SEABOARD GROUP II AND THE CITY OF HIGH POINT

Re: Response to Comments on TM-11 Fourth Quarter and Final Summary Report Former Seaboard Chemical and Riverdale Drive Landfill Site Jamestown, Guilford County, North Carolina EPA ID No. NCD071574164/ Solid Waste Permit No. 4101-MSWLF-1979

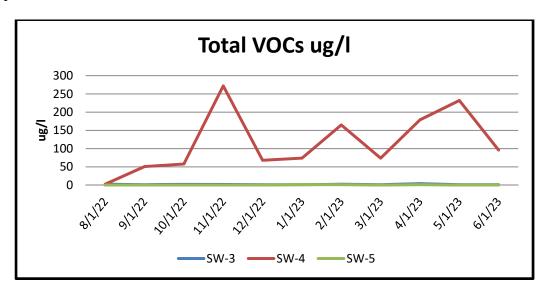
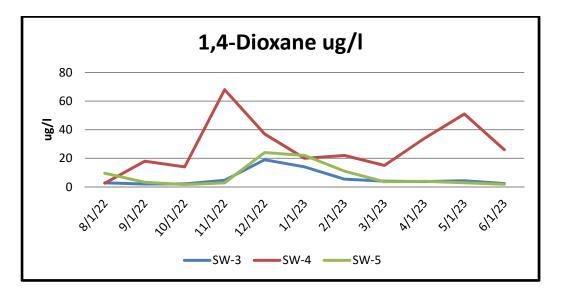
2. <u>Comment</u>: In Section 3.2 and in Section 5 (Conclusions and Recommendations), you indicated that the expanded groundwater capture zone at the SIS basin appears to have improved Surface Water Quality at the SW-4 monitoring location and the graph for 1,4-dioxane is shown on Page 7. Did the laboratory test samples of SW-4 for VOCs during one or more of the four quarters, and if yes, did VOC concentrations trend downward?

<u>Response</u>: A comparison of the historical total VOCs and 1,4-dioxane in the surface water samples in the SIS drainage basin during the Extraction System Evaluation is provided below:

As shown on the graphs, total VOCs exhibited decreasing concentration trends similar to decreasing trends observed for 1,4-dioxane.
